# Access Compliance Report

## Public Rights-of-Way

### (Curb Ramps)

Intersection ID: 26714	Main Street: NANCY_CREEK_RD	Cross Street: OPEN_BOOK_LN	Location: NE
ADA ID: C33482193F9A	Ramp Type: BlendTrans1	Initial Pass/Fail: Fail	Overall Compliance: No
Severity Score: 12.5			
Codes/Mitigation Info/Possible Solution		Field Measurements/Component Compliance

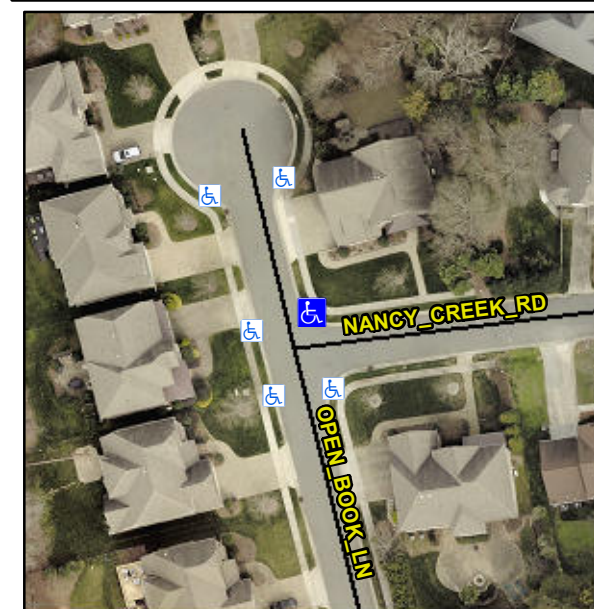
**Not Found, R304.5.3**

Compliance	Description	Data	Compliance	Description	Data
N/A	Ramp Length (in)	48.0	Yes	BlendTrans Slope (%)	2.8
Yes	Ramp Width (in)	48.0	No	BlendTrans XSlope (%)	5.3
N/A	Flare Type LT	N/A	N/A	Flare Type RT	N/A
N/A	Flare Slope LT (%)	N/A	N/A	Flare Slope RT (%)	N/A
N/A	Flare Traversable LT?	N/A	N/A	Flare Traversable RT?	N/A
N/A	Landing Length (in)	N/A	N/A	DWS Provided?	N/A
N/A	Landing Width (in)	N/A	N/A	DWS Contrast?	N/A
N/A	Landing Slope (%)	N/A	N/A	DWS Length (in)	N/A
N/A	Landing X Slope (%)	N/A	N/A	DWS Full Width?	N/A
N/A	Landing Curb? (Y/N)	N/A	N/A	DWS Offset (in)	N/A
N/A	Shared Landing?	N/A			
N/A	Gutter Ponding?	N/A	N/A	Gutter Slope (%)	N/A
N/A	Gutter Lip Ht (in)	N/A	N/A	Gutter X Slope (%)	N/A
N/A	Painted X Walk1?	No	N/A	Painted X Walk2?	No
	X Walk 1 Direction	To W		X Walk 2 Direction	To S
	X Walk 1 Width (in)	N/A		X Walk 2 Width (in)	N/A
	X Walk 1 Slope (%)	2.6		X Walk 2 Slope (%)	5.5
	X Walk 1 X Slope (%)	5.6		X Walk 2 X Slope (%)	1.8

N/A	Ramp inside XWalk1?	N/A	N/A	Ramp inside XWalk2?	N/A
	Road Slope (%)	4.3		Clear Space?	N/A
	Road X Slope (%)	5.5	N/A	Clear Space to XWalk (in)	N/A
N/A	Any Obstructions?	N/A	N/A	Storm Grate/Utility Hazard?	N/A
	Obstruction Type			Storm Grate/Utility Type	
		N/A			N/A
			Yes	Surface Condition? (G/P)	Good
			No	Curb Slope (%)	15.2

**Remove & Replace Curb Ramp With Two New Directional Ramps or Equivalent.**
